PROJECT NAME: Miraflor Apartments (MSPM 19-008)

APPROVAL SOUGHT: Request for Major Site Plan modification approval to construct multifamily residential development consisting of 58 rental apartments within five (5), two/three-story structures with associated residential improvements on 3.87 acres zoned IPUD.

EXHIBIT "C"
CONDITIONS OF APPROVAL

Project Name: Miraflor Apartments
 File number: MSPM 19-008
 Reference: 3rd review plans identified as a Major Site Plan Modification with a February 11, 2020 Planning and Zoning Department date stamp marking.

SHEET TITLE
BLDG 4
ELEVATIONS

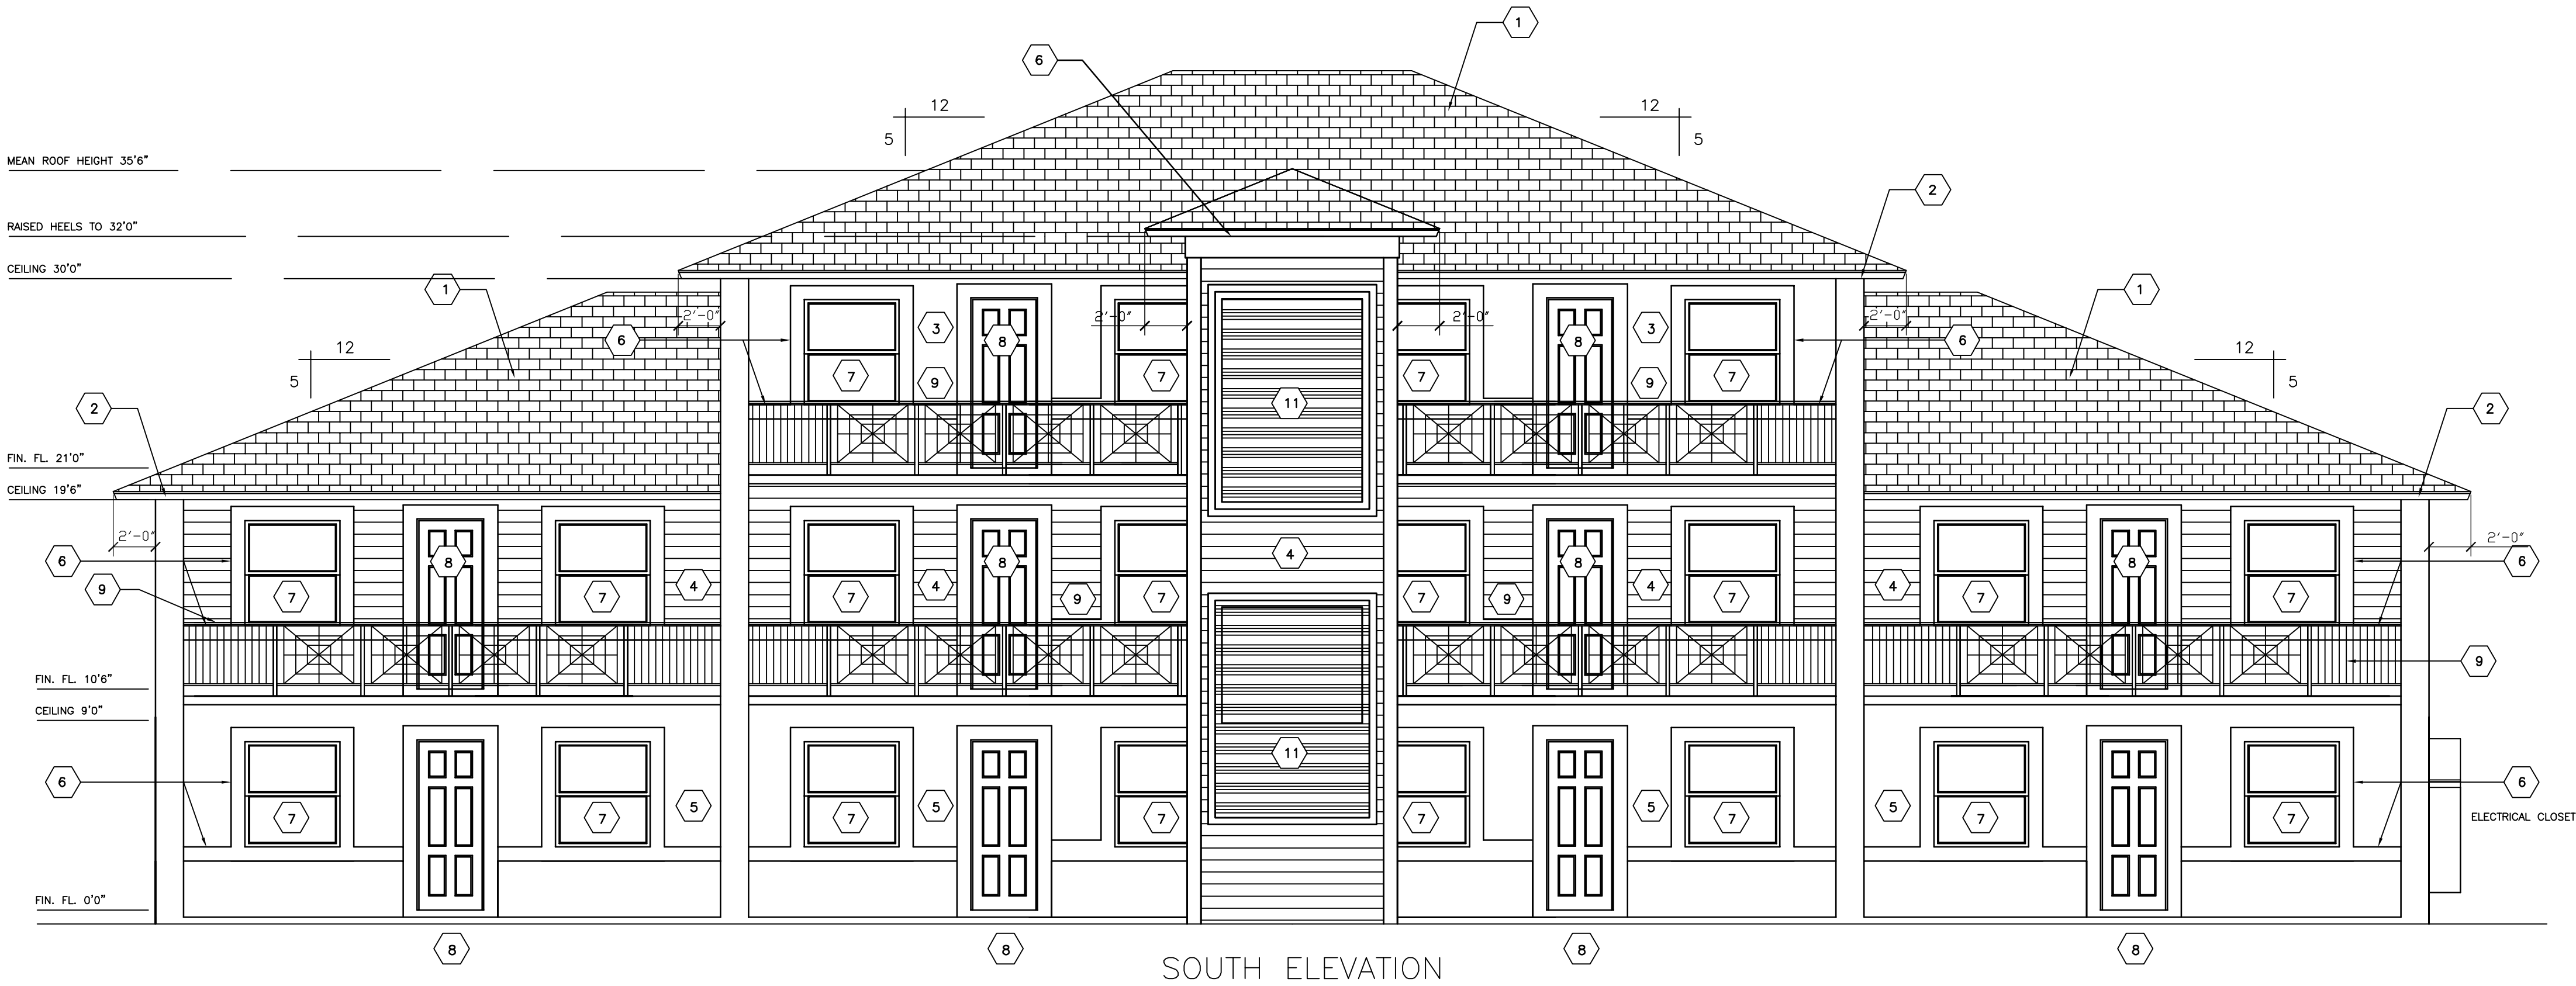
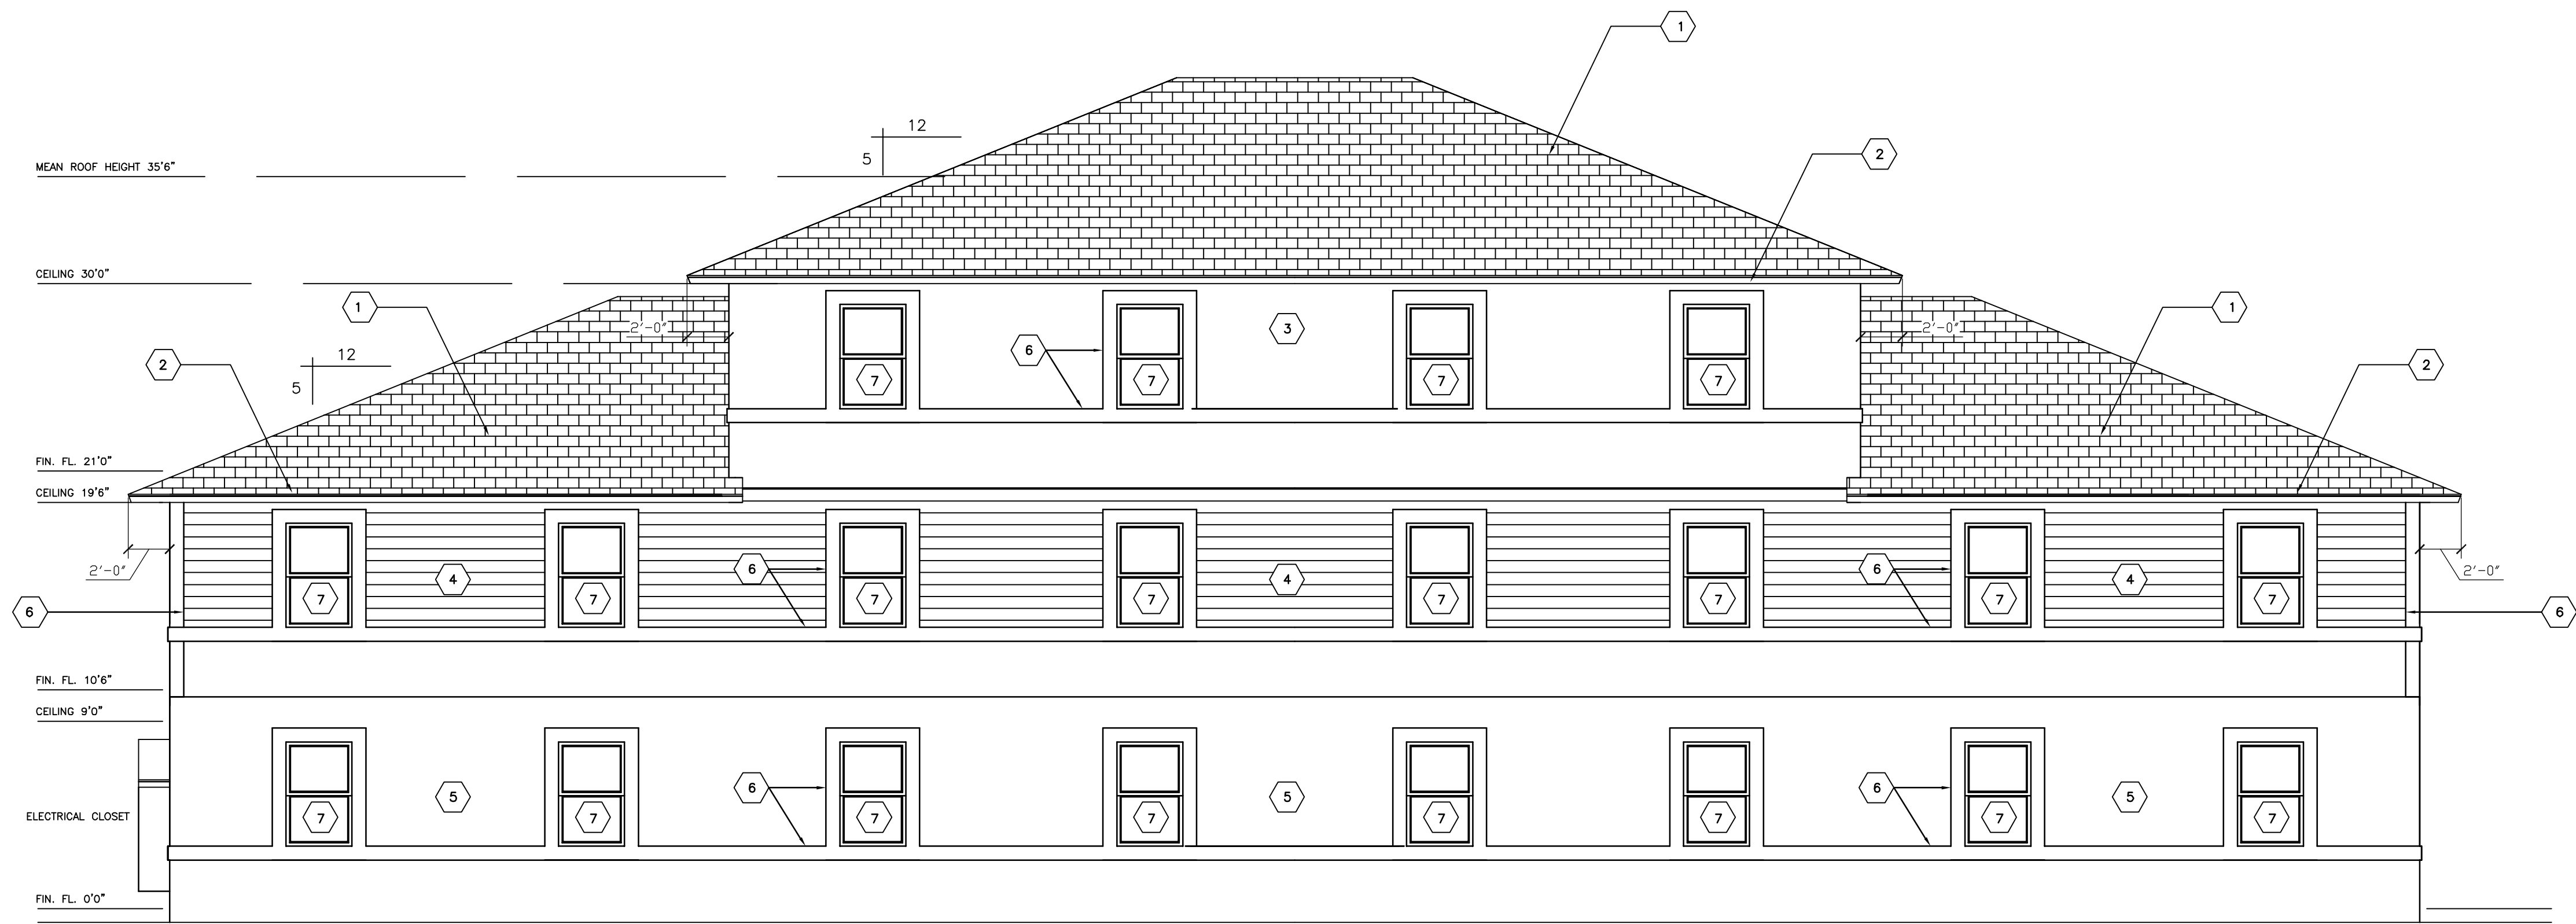
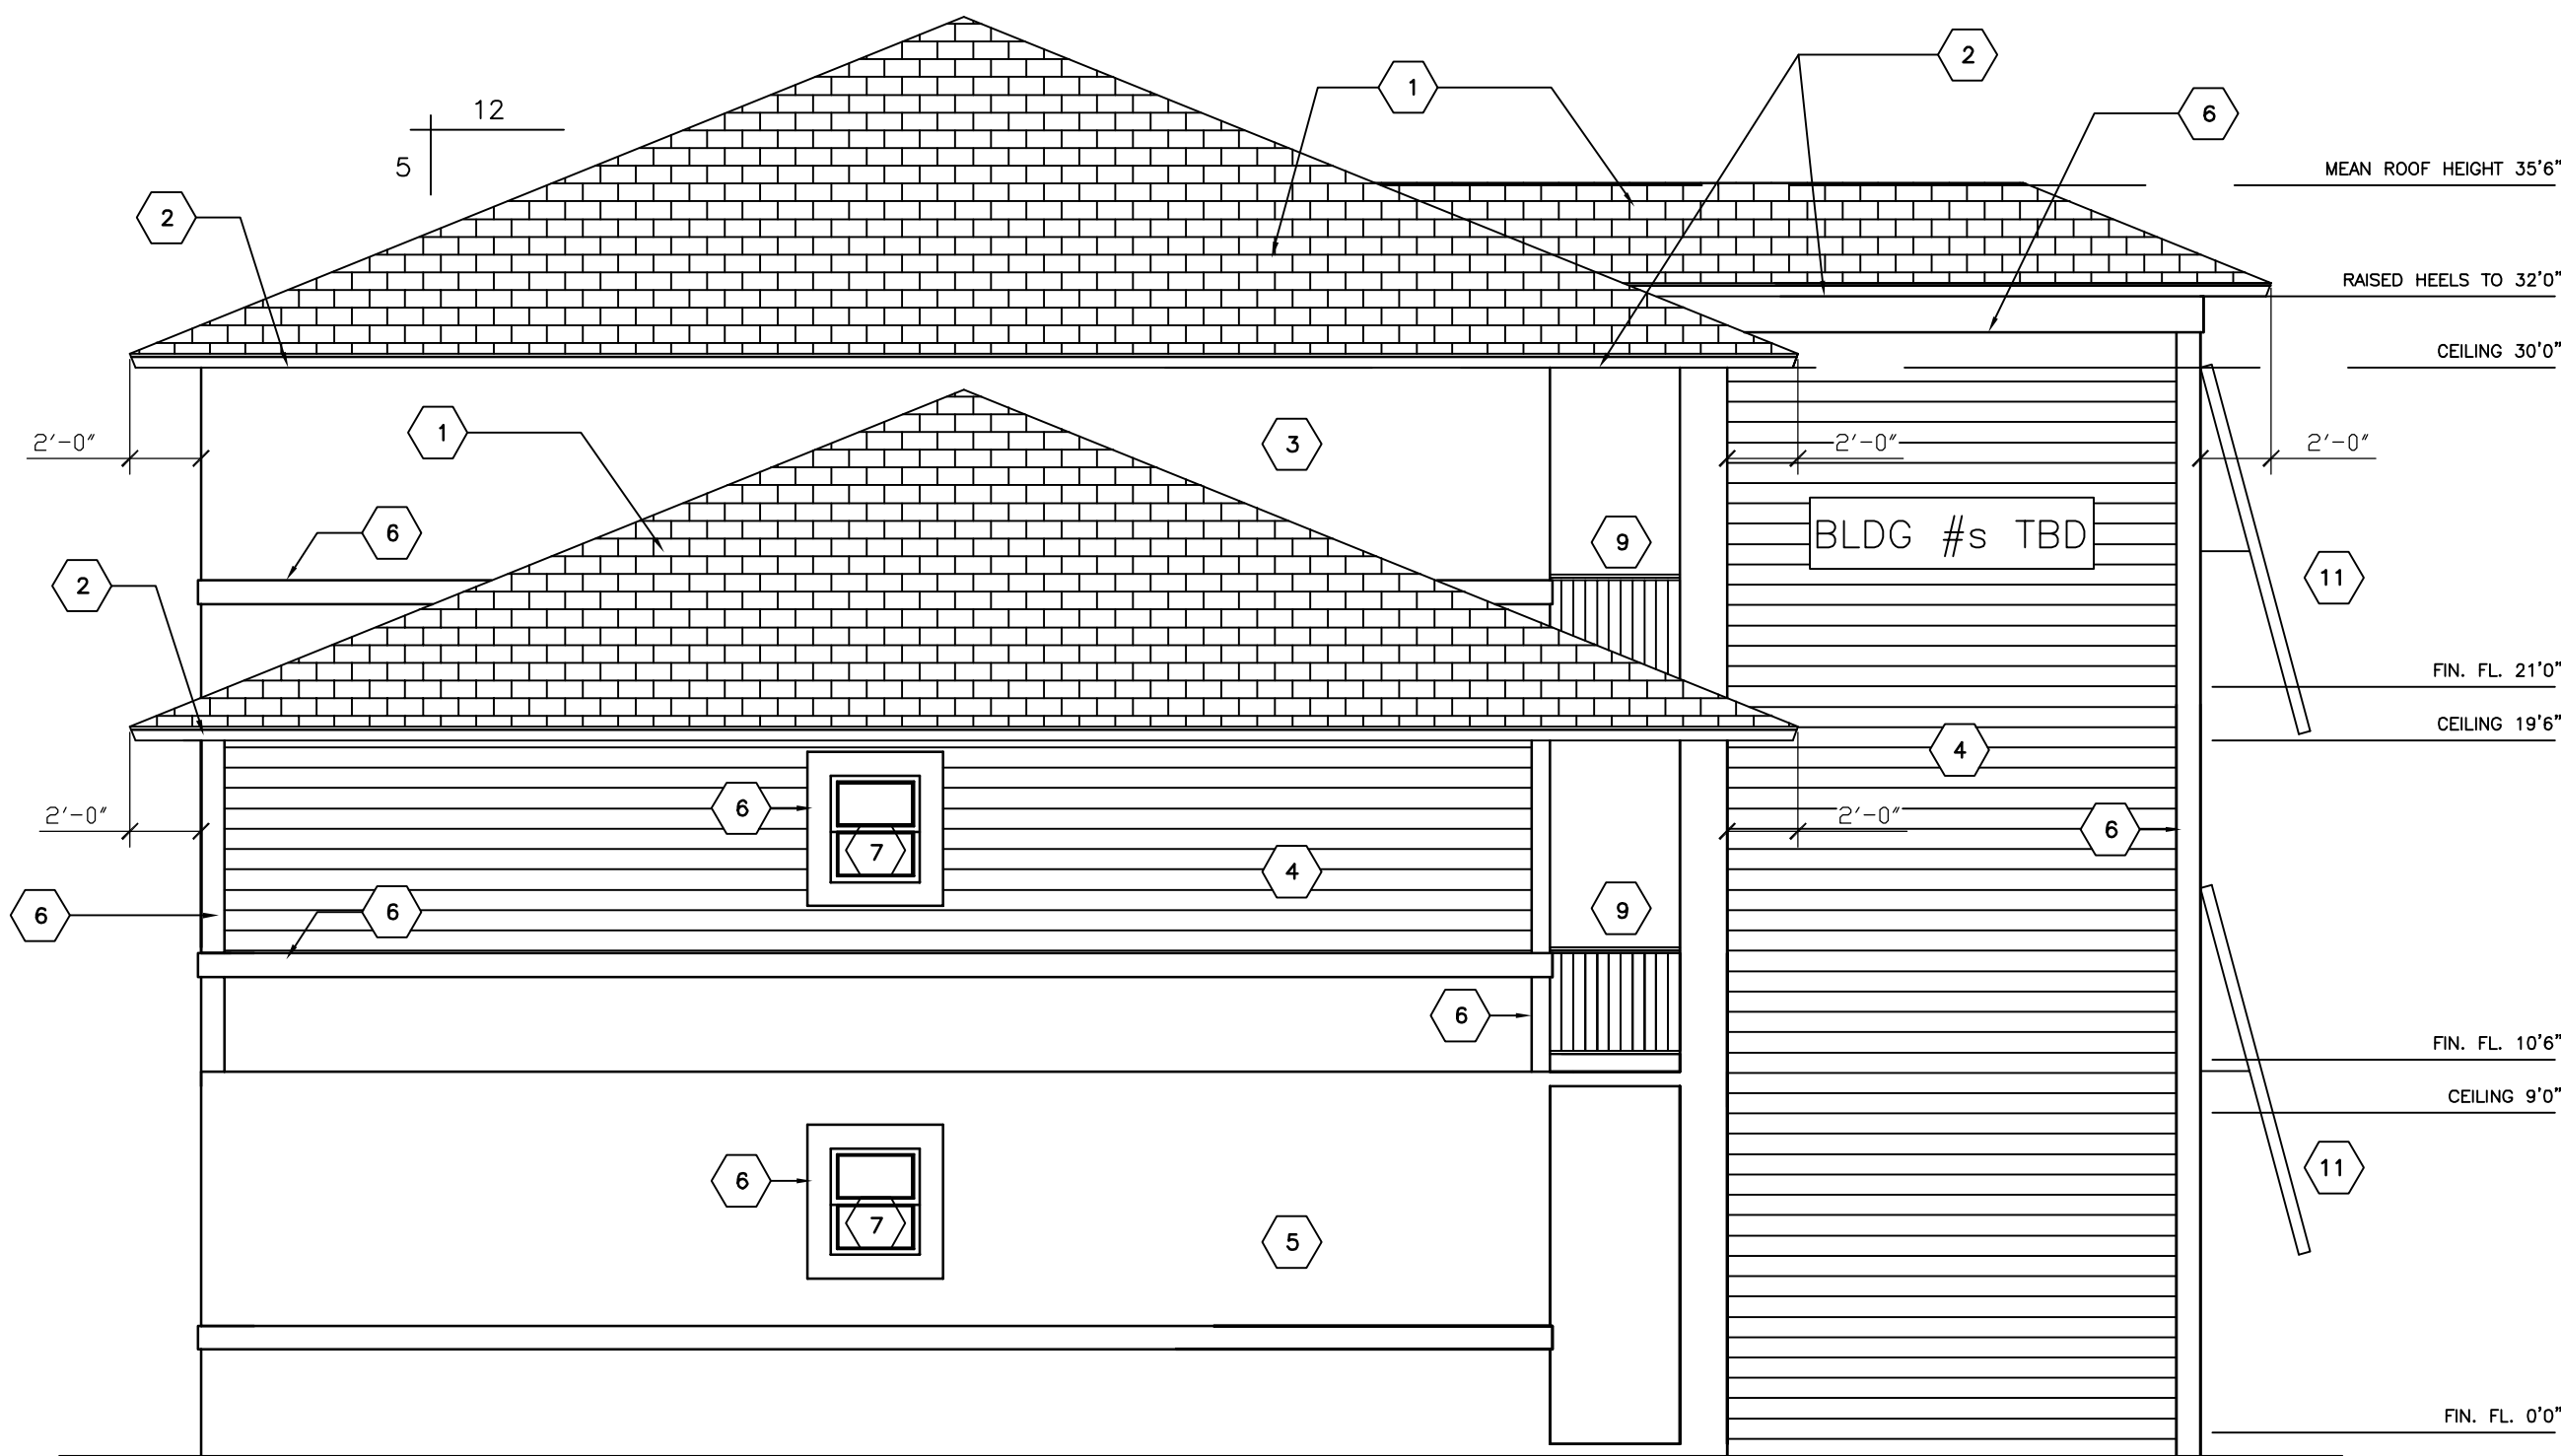
DEPARTMENTS	INCLUDE	REJECT
monument sign structure must be located at least 10 feet from property lines and shall not be internally illuminated.		
13. At time of permitting further revise elevations to enhance facades for buildings that are directly visible from abutting roadways and adjacent development by adding a decorative medallion on lapped stucco walls (Buildings 1 and 3 south elevations; Building 4 east elevation; and Building 5 north and south elevations).	√

SHEET TITLE
BUS STOP
ELEVATIONS

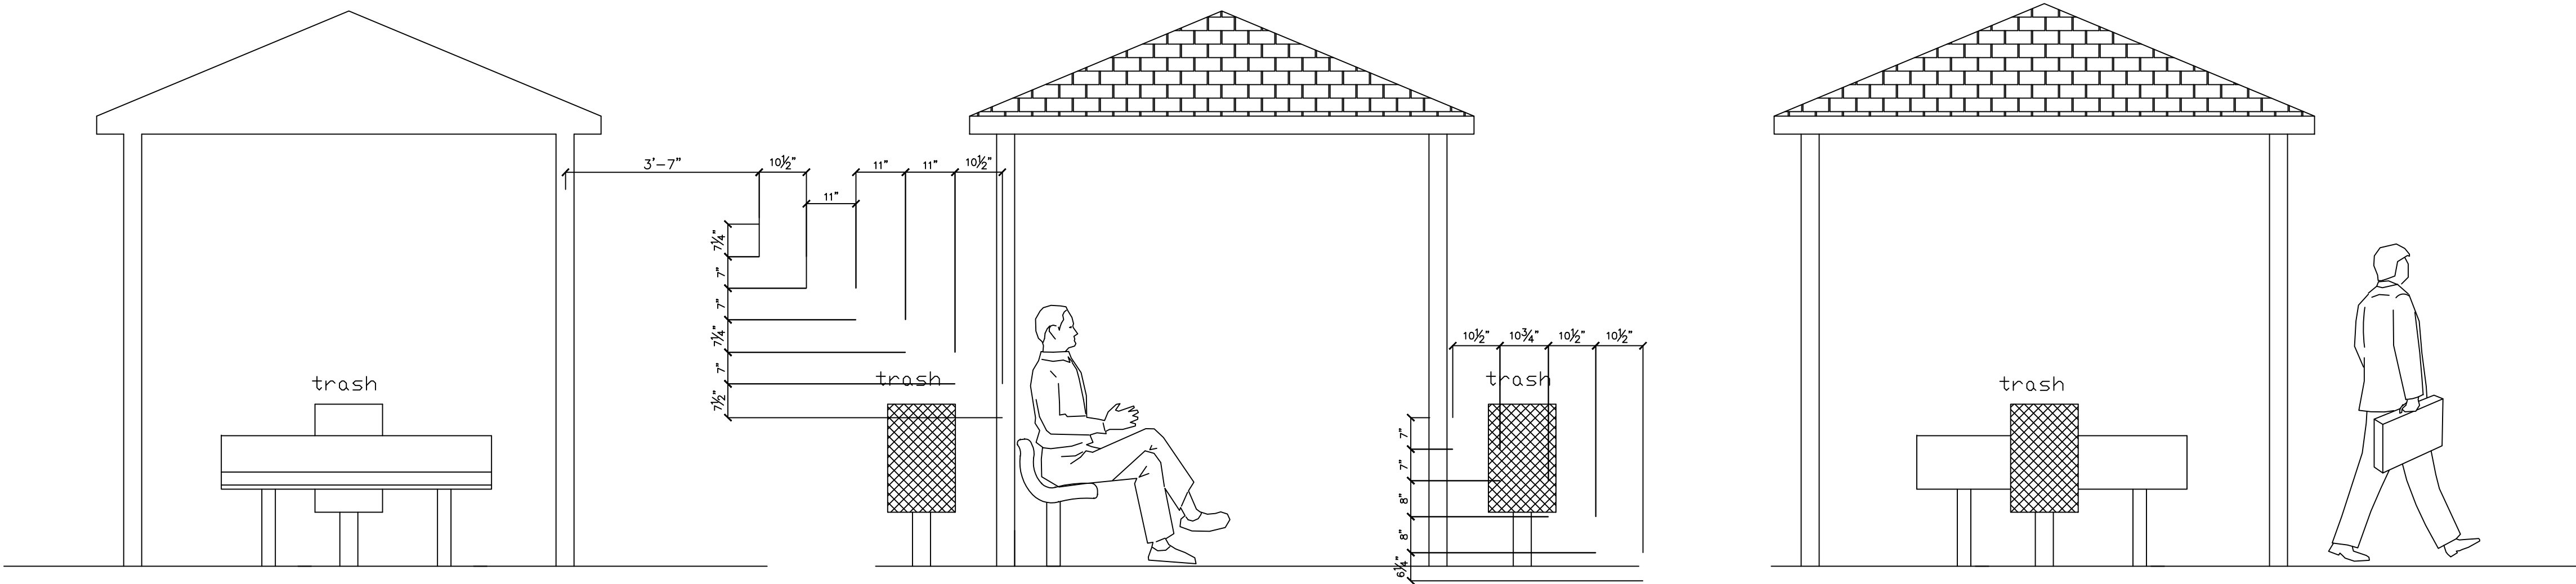
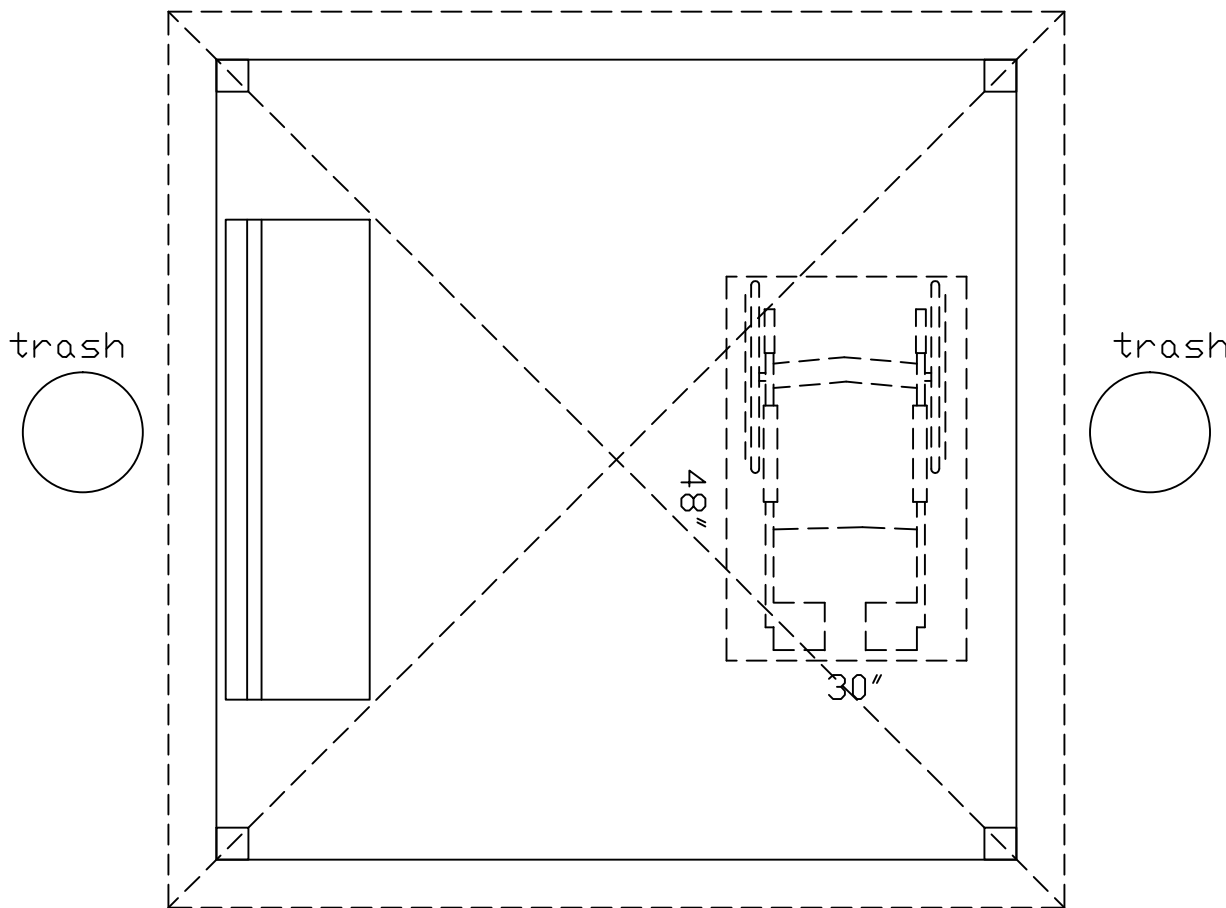
10. The subject site is located along a Palm Tran bus route and a proposed bus stop is labeled on the site plan along Seacrest Boulevard within the Palm Tran easement. Staff recommends installing an upgraded bus shelter. Coordinate the design with Palm Tran. At time of permitting provide an elevation and detail of the proposed upgraded bus shelter on the plans.	√
